**Notification subject:** ERRATA - PIC24FJ256GB110 Family Silicon/Data Sheet Errata Errata Document Revision

**Notification text:** SYST-28XTEV399

## **Product Change Notification - SYST-28XTEV399**

## PIC24FJ256GB110 Family Silicon Errata and Data Sheet Clarification

**FIGURE 2-3 FREQUENCY vs. ESR PERFORMANCE FOR SUGGESTED VCAP**

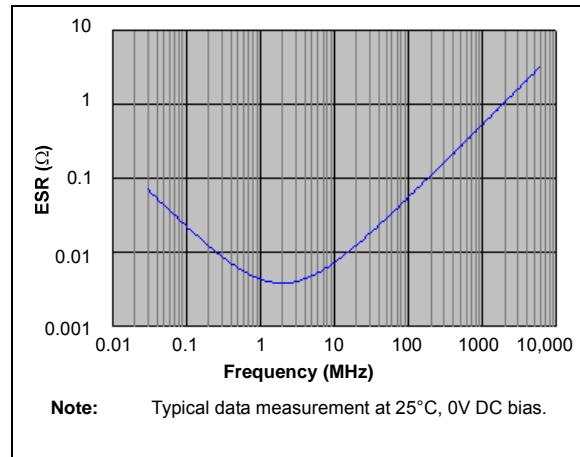
Designers may use [Figure 2-3](#) to evaluate ESR equivalence of candidate devices.

**FIGURE 2-4 DC BIAS VOLTAGE vs. CAPACITANCE CHARACTERISTICS**

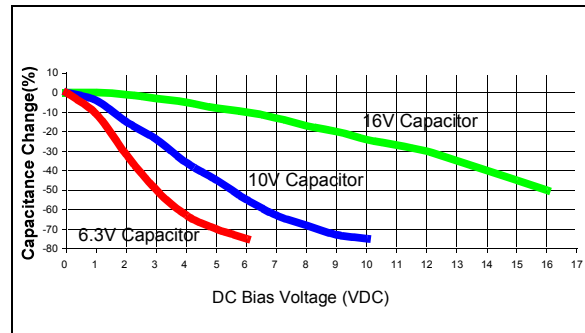
A typical DC bias voltage vs. capacitance graph for 16V, 10V and 6.3V rated capacitors is shown in Figure 2-4.

When selecting a ceramic capacitor to be used with the internal voltage regulator, it is suggested to select a high-voltage rating, so that the operating voltage is a small percentage of the maximum rated capacitor voltage. For example, choose a ceramic capacitor rated at 16V for the 2.5V core voltage. Suggested capacitors are shown in Table 2-1.

**FIGURE 29-1: PIC24FJ256GB110 FAMILY VOLTAGE-FREQUENCY GRAPH (INDUSTRIAL)**

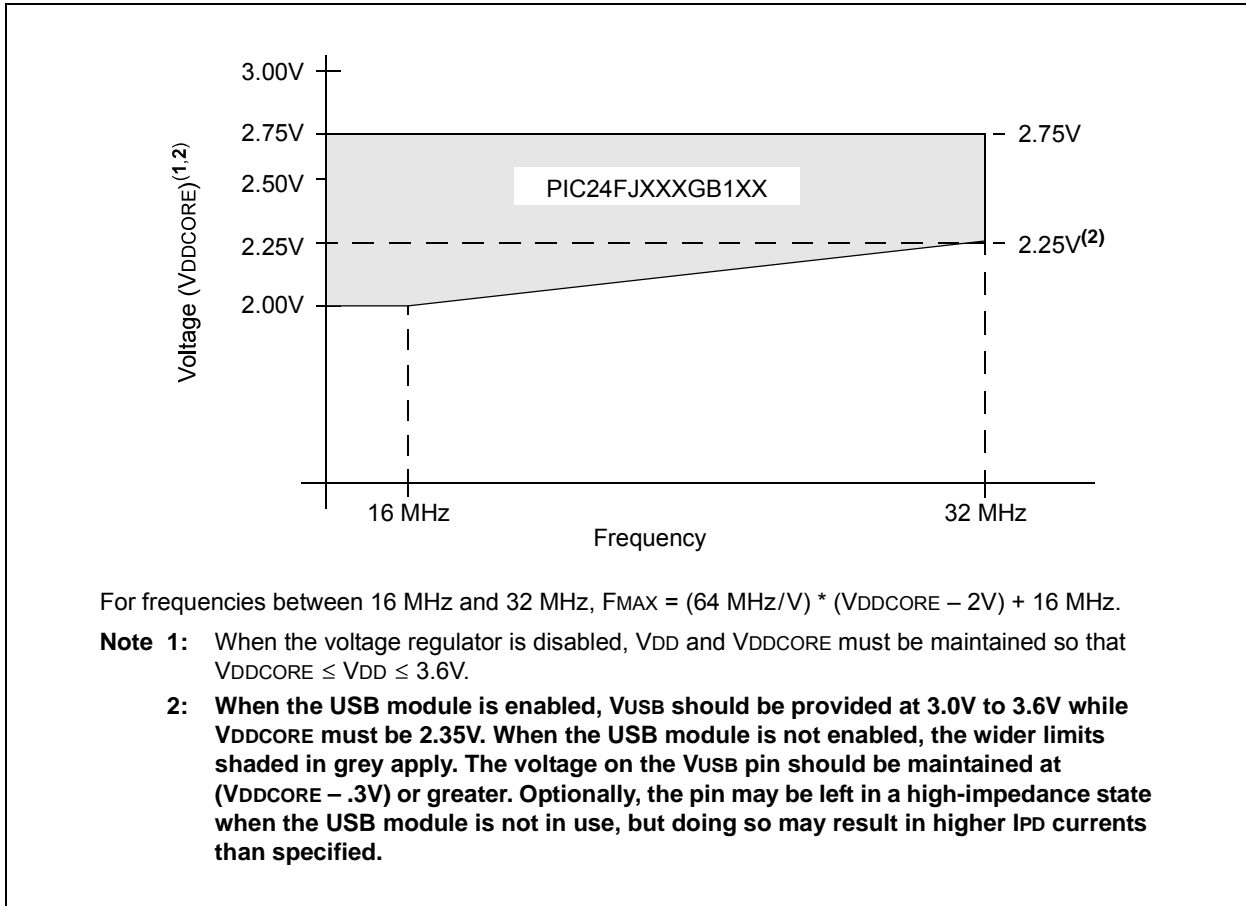
Figure 29-1 (“PIC24FJ256GB110 Family Voltage-Frequency Graph”) is amended by adding an additional footnote. The updated figure is shown below (changes in **bold**; bold in original removed for clarity).
